Serial No. 04-347  
ESP/JDH  
Docket No. 52-008

**DOMINION NUCLEAR NORTH ANNA, LLC**  
**NORTH ANNA EARLY SITE PERMIT APPLICATION**  
**RESPONSE TO REQUEST FOR ADDITIONAL INFORMATION NO. 5**

**Enclosure 1**  
**Response to NRC RAI Letter No. 5**

Figure 1. Hazard curves for 1 Hz spectral acceleration.

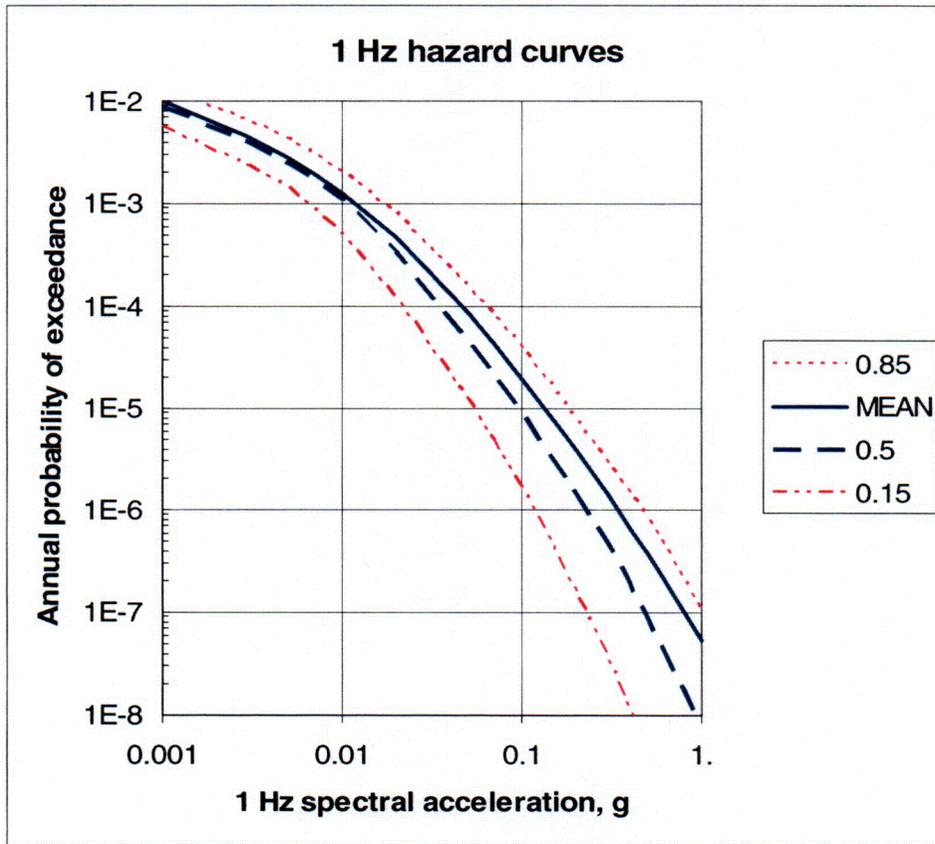
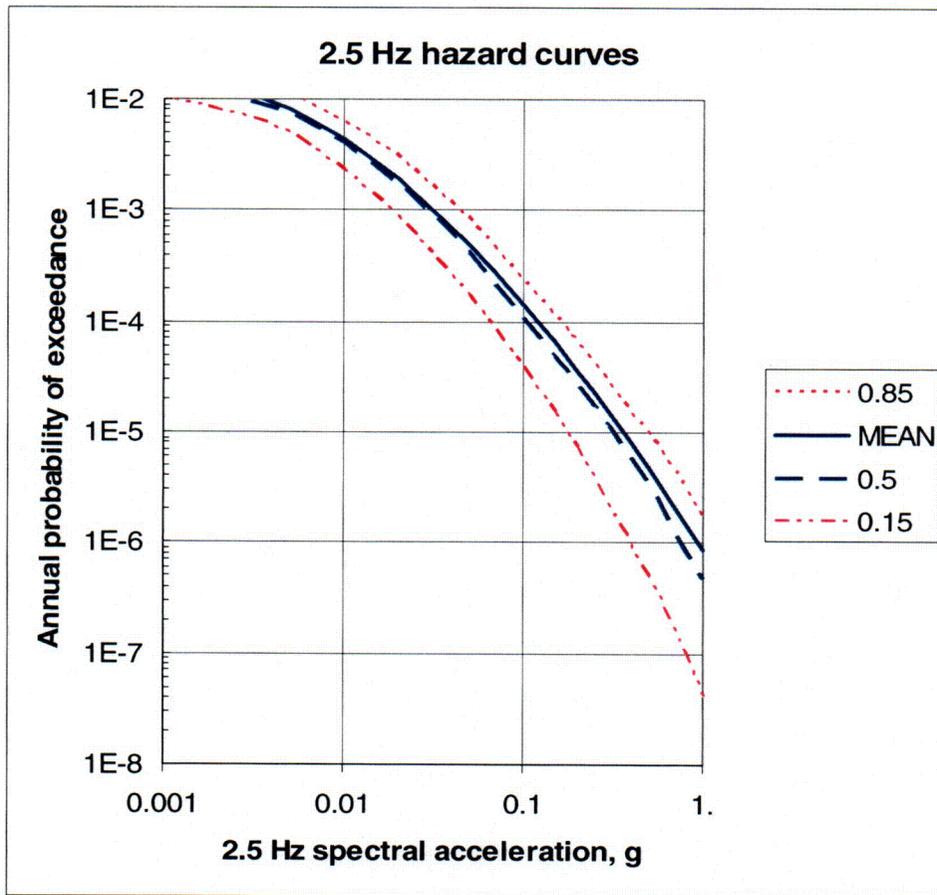
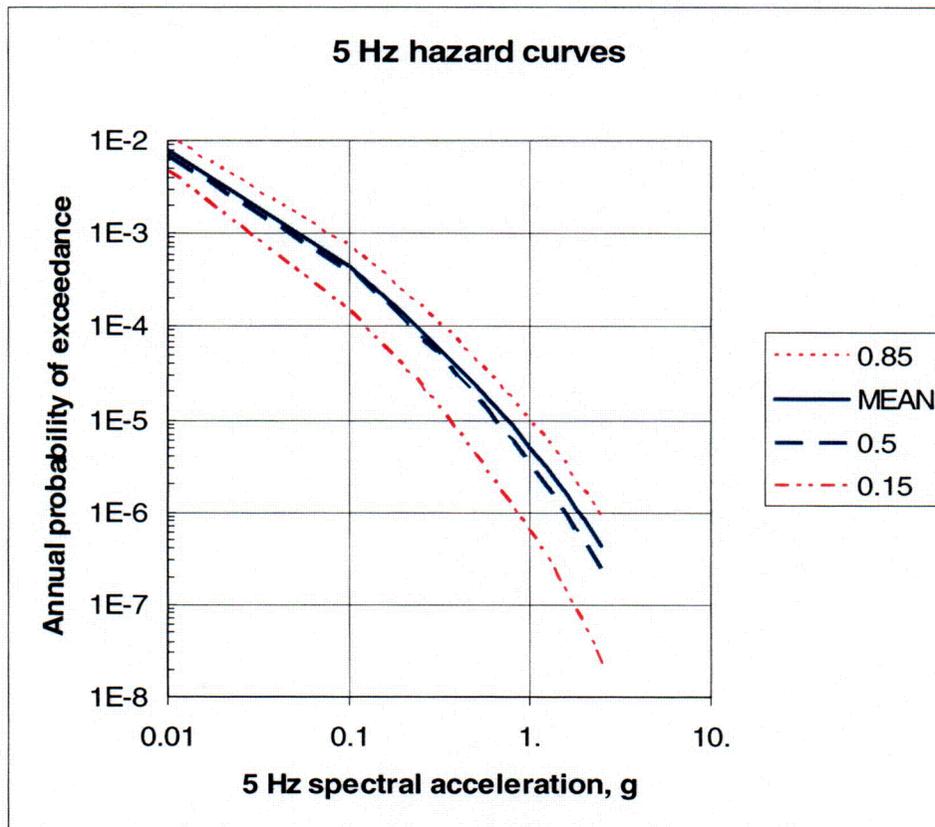
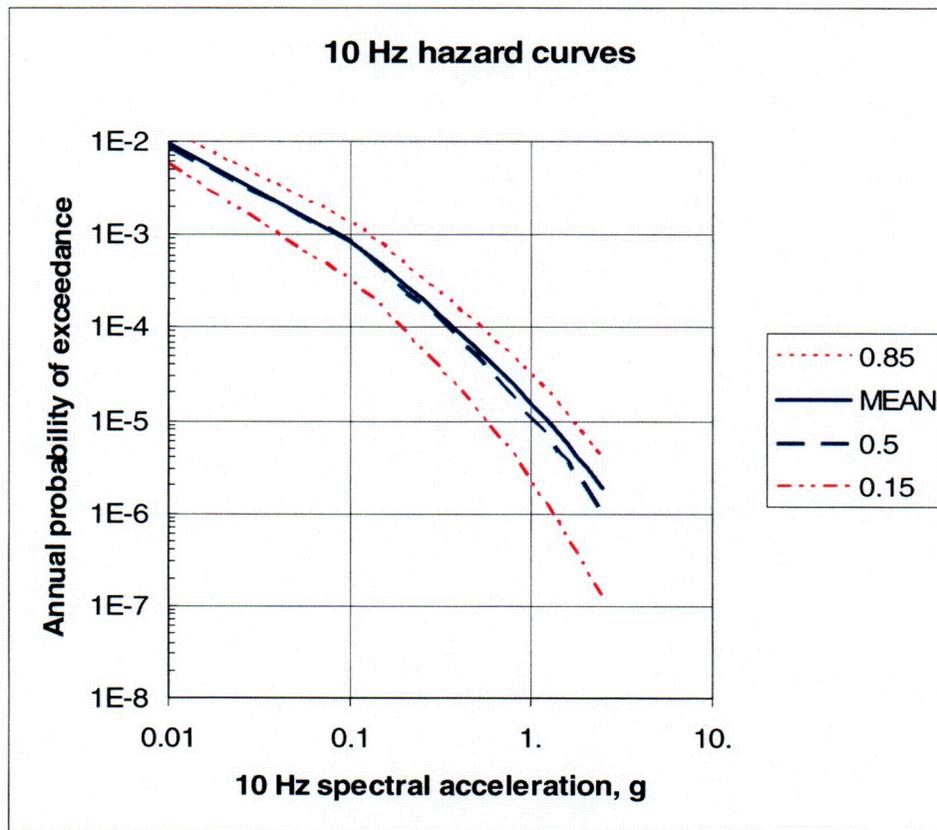
SSAR Figures 2.5-44 and 2.5-45 provide mean and median hazard curves for 1 Hz and 10 Hz spectral acceleration. Please provide the 15<sup>th</sup> and 85<sup>th</sup> percentile hazard curves for both 1 and 10 Hz spectral acceleration. In addition, please provide the mean, median, 15<sup>th</sup>, and 85<sup>th</sup> percentile hazard curves for both 2.5 and 5 Hz spectral acceleration.

The mean, median, 15<sup>th</sup>, and 85<sup>th</sup> percentile hazard curves for 1 Hz, 2.5 Hz, 5 Hz, and 10 Hz spectral acceleration are shown in Figures 1 through 4, respectively. (Figures are located at the end of this RAI response.) Note that SSAR Figures 2.5-44 and 2.5-45 compare seismic hazard with the 1989 and 2003 EPRI ground motion equations without the inclusion of seismic hazard from the ECFS-S fault, whereas Figures 1 through 4 include seismic hazard from the ECFS-S fault. The median 1 Hz curve in Figure 1 matches the "Original+ECFS-S, median" hazard curve in SSAR Figure 2.5-40. The mean 1 Hz curve in Figure 1 matches the "Original+ECFS-S, mean" hazard curve in SSAR Figure 2.5-41. The median 10 Hz curve in Figure 4 matches the "Original+ECFS-S, median" hazard curve in SSAR Figure 2.5-42. The mean 10 Hz curve in Figure 4 matches the "Original+ECFS-S, mean" hazard curve in SSAR Figure 2.5-43.

Figure 2. Geologic map of the site area with Fault "A" highlighted. Geology taken from Mixon et al. (2000) Fredericksburg 100k quadrangle and Marr (2002) western portion of Richmond 100k quadrangle.

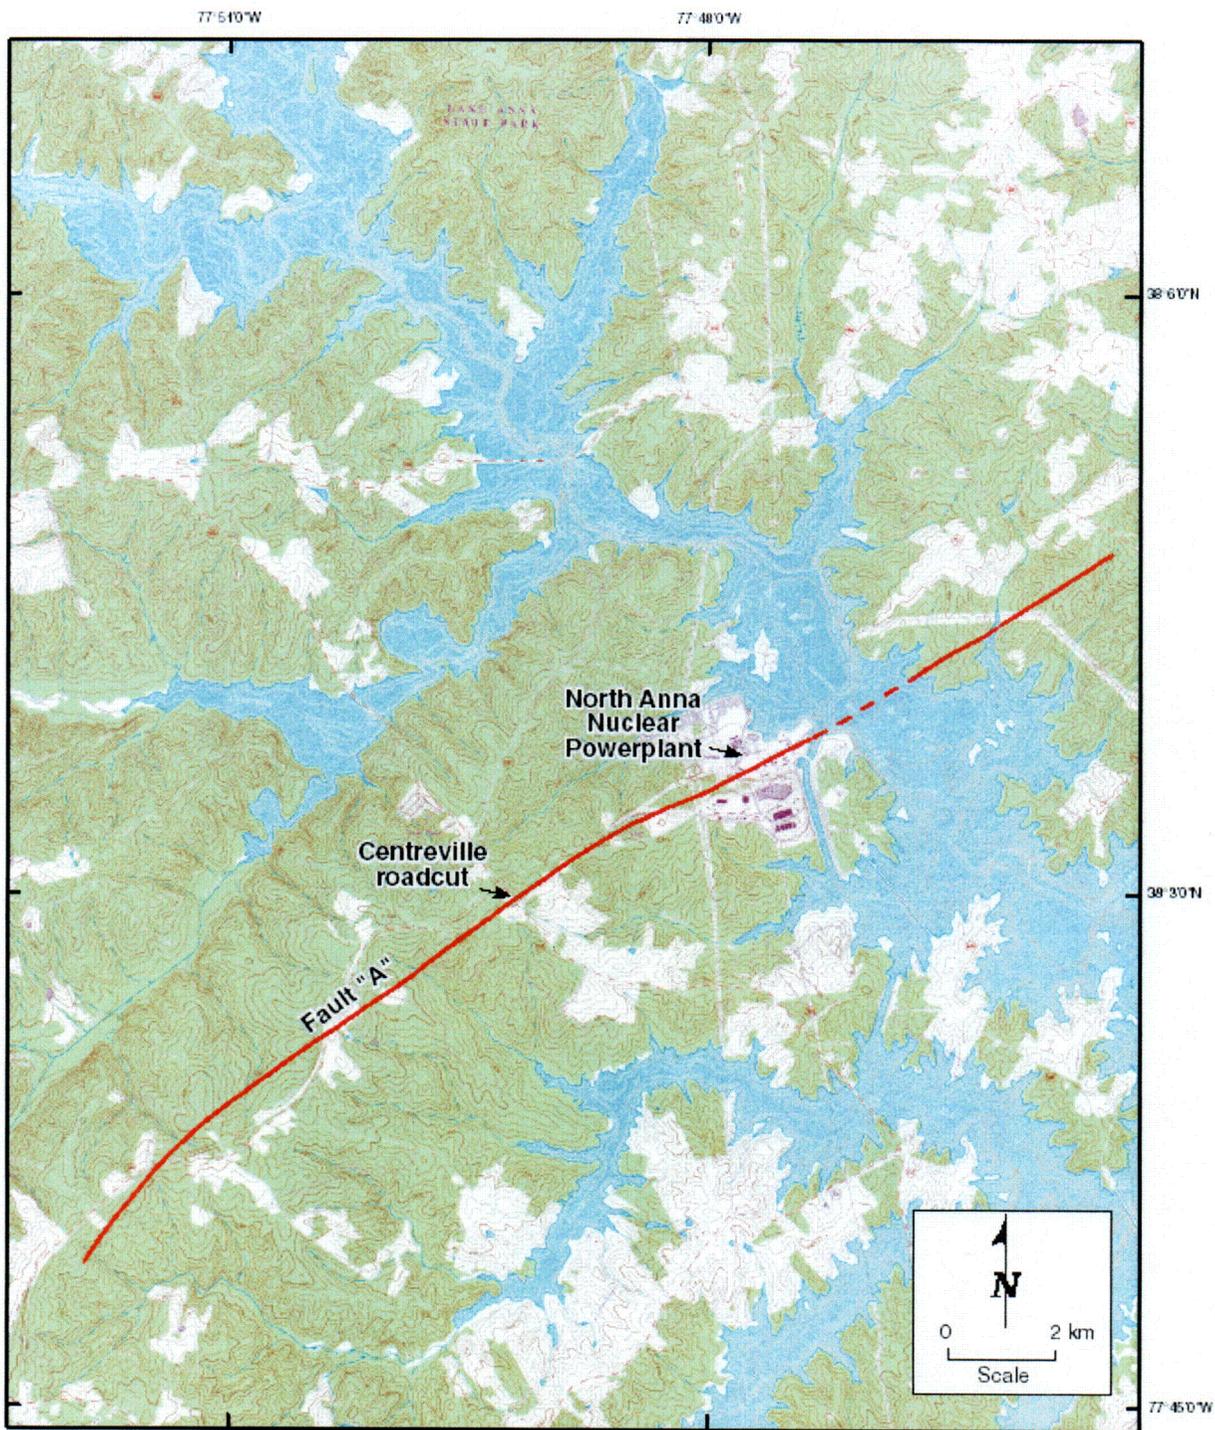
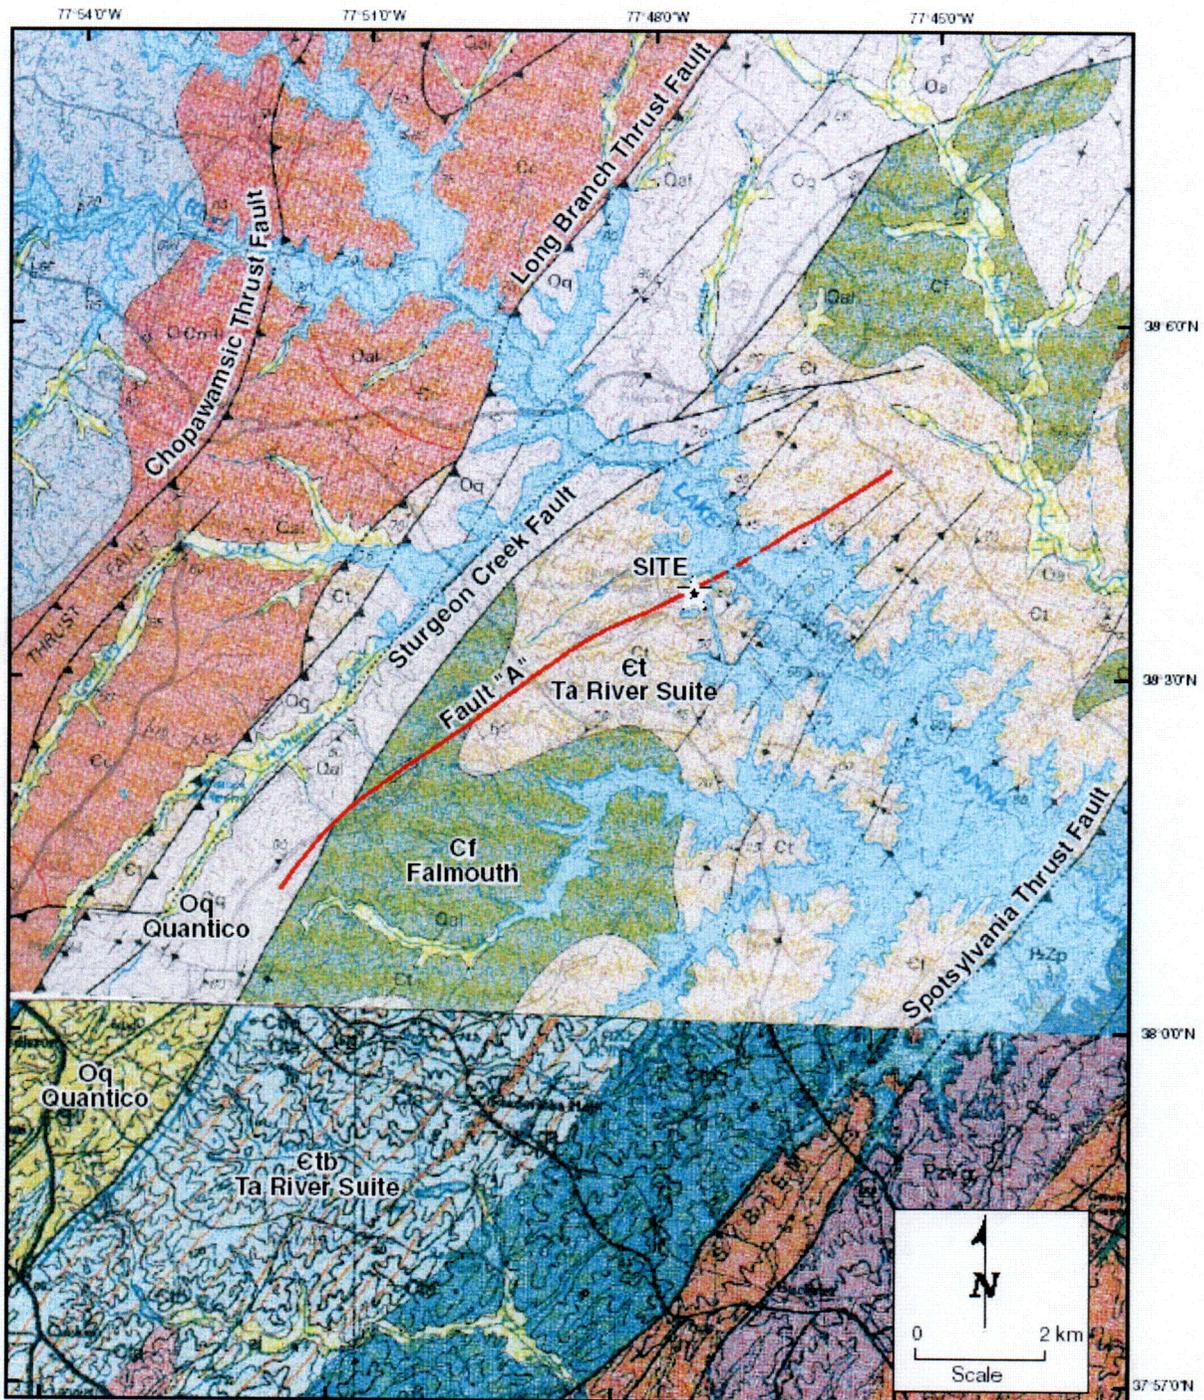
SSAR Subsection 2.5.3.2.2 states that aerial reconnaissance, field reconnaissance, and air photo interpretation did not reveal evidence for the southwestward continuation of unnamed fault "a" beyond the ESP site as mapped by Pavlides (Reference 36), which was compiled onto the map of Mixon and others (Reference 66). Please provide support for this conclusion by describing (1) the map relations shown by Pavlides and Mixon and others that implied the extension of unnamed fault "a" beyond the ESP site, (2) the field observations that raise questions about the map relations, and (3) information on the adjacent geologic sheet, suggested as an alternative interpretation, that does not call for the extension of unnamed fault "a" beyond the ESP site.

As shown on Figure 2, fault "a" is mapped within the Cambrian Ta River metamorphic suite near the site. Pavlides does not map any offset stratigraphic contacts in the Lake Anna area to support the mapped location of the fault. To the southwest, Pavlides interprets the fault to cross the contact between the Ta River metamorphic suite and the Carboniferous Falmouth intrusive suite and between the Falmouth intrusive suite and the Ordovician Quantico Formation. On all four Pavlides maps (1989, 1990, 1994, and 1995), these contacts are not shown to be offset. However, on the compilation map by Mixon et al. (2000), these contacts are shown to be offset in a right lateral sense. Under close inspection of the original mapping by Pavlides (1980, 1990) compared to the compilation map by Mixon et al (2000), the apparent offsets in the stratigraphic contacts shown by Mixon et al (2000) appear to be a compilation error. The apparent offsets shown on the Mixon et al (2000) map are within the line weight of the contacts shown on the Pavlides (1990) map. In addition, the apparent right lateral offset of the Falmouth intrusive suite is opposite to the sense of movement as shown for other faults

with a similar northeast trend in the region, such as the Sturgeon Creek fault directly to the west (Figure 2). Unfortunately, Pavlides is deceased and the basis for his mapping of fault "a" and whether or not the margin of the Falmouth intrusive contact is displaced is not known. Neither Pavlides (1980, 1990) or Mixon et al (2000) describe fault "a" or any stratigraphic, structural, or geomorphic evidence that would support the existence of fault "a" other than the possible offset contacts noted above.

The map contact between the Fredericksburg quadrangle mapped by Mixon et al (2000) and the Richmond quadrangle mapped by Marr (2002) occurs directly south of the southern end of the mapped location of fault "a" (Figure 2). Mixon et al (2000) show fault "a" terminating southward within the Quantico formation. Marr (2002) does not show a corresponding fault along the southwestern projection of fault "a". In addition, several other features mapped at the southern edge of the Fredericksburg quadrangle by Mixon et al (2000), such as the Falmouth intrusive suite and the Sturgeon Creek fault, are not shown on the adjacent Richmond sheet (Marr, 2002). Marr published his map after Pavlides (1980, 1990) and Mixon et al (2000) published their maps of the Fredericksburg quadrangle and, therefore, had the opportunity to verify and include these features on his map, but he did not. Based on our field reconnaissance and air photo interpretation, we concur with Marr (2002) that the Ta River metamorphic suite contains lenses of quartzite within the more mafic metamorphic rock, as opposed to the recognition and differentiation of distinct intrusive complexes as shown by Pavlides (1990) and Mixon et al. (2000). If the interpretation of the Ta River metamorphic suite by Marr is correct, then the existence and offset of the Falmouth intrusive complex along fault "a" as shown by Pavlides (1990) and Mixon et al (2000) is not correct.

Figure 1.  $G/G_{max}$  versus Shear Strain Curves for Sands and Clay

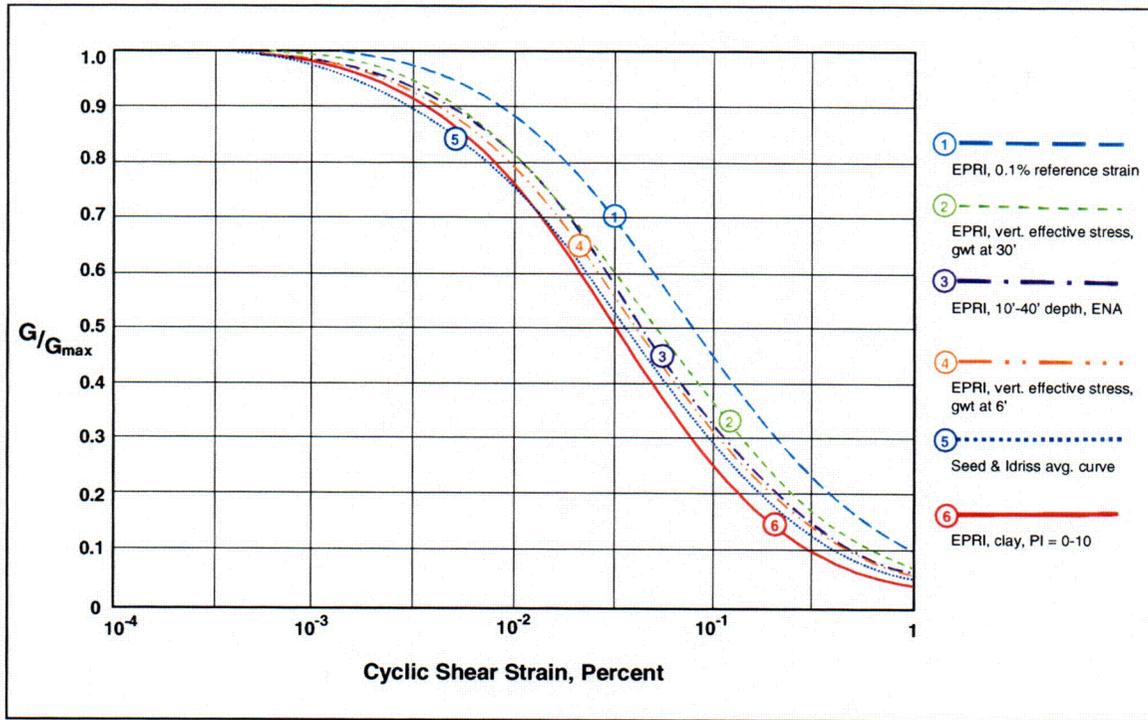
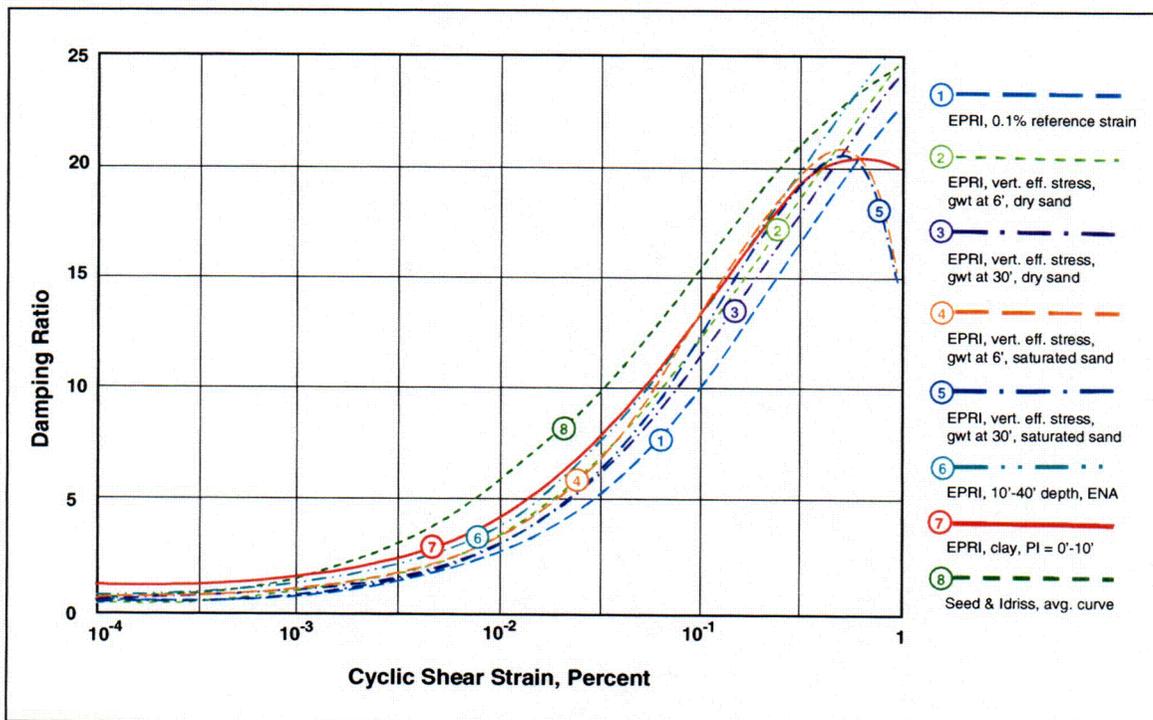
- a) Please provide the basis for the selected modulus reduction curves for Zone IIA saprolite, Zone IIB saprolite, and Zone III weathered rock.

- c. Page 4 of Exhibit 2. These curves are suitable for generic site response studies in Eastern North America, and cover the range from gravelly sands to low plasticity clays. A curve was interpolated for 10 to 40 feet depth for the North Anna sands. This curve is closer to the 20 to 50 feet curve than the 0 to 20 feet curve. It is plotted as curve 3 on Figure 1.
- d. Page 5 of Exhibit 2. This shows modulus reduction curves for clays, demonstrating the variation with plasticity index. The cohesive portions of the Zone IIA saprolite are generally low plasticity. Curve 6 on Figure 1 is for a PI of 10. For PI = 30, the curve is close to curve 1 on Figure 1.

Curve 5 on Figure 1 is the average Seed and Idriss (1970) curve for sands that has been used in many SHAKE analyses.

The curves in Figure 1 fall into a fairly close group. The average curve is close to curves 3 and 4. This curve is plotted as curve 1 on SSAR Figure 2.5-63 and is the design curve for the Zone IIA saprolite. The curve is tabulated below.

The curves on Pages 2 and 3 of Exhibit 5 are spaced proportionally to the log of the effective vertical pressure. These were interpolated for effective vertical pressures of 1,313 psf and 1,875 psf for the dry sands and plotted as curves 2 and 3, respectively, on Figure 2. For the saturated sands, the curves are plotted as curves 4 and 5, respectively, on Figure 2.

- c. Page 4 of Exhibit 5. These curves are suitable for generic site response studies in Eastern North America, and cover the range from gravelly sands to low plasticity clays. A curve was interpolated for 10 to 40 feet depth for the North Anna sands. This curve is closer to the 20 to 50 feet curve than the 0 to 20 feet curve. It is plotted as curve 6 on Figure 2.
- d. Page 5 of Exhibit 5. This shows damping ratio versus shear strain curves for clays, demonstrating the variation with plasticity index. The cohesive portions of the Zone IIA saprolite are generally low plasticity. Curve 7 on Figure 2 is for a PI of 10.

Curve 8 on Figure 2 is the average Seed et al (1970) curve for sands that has been used in many SHAKE analyses.

The curves in Figure 2 fall into a fairly close group. The average curve is closest to curve 2. This average curve is plotted as curve 1 on SSAR Figure 2.5-64 and is the design curve for the Zone IIA saprolite. The curve is tabulated below.
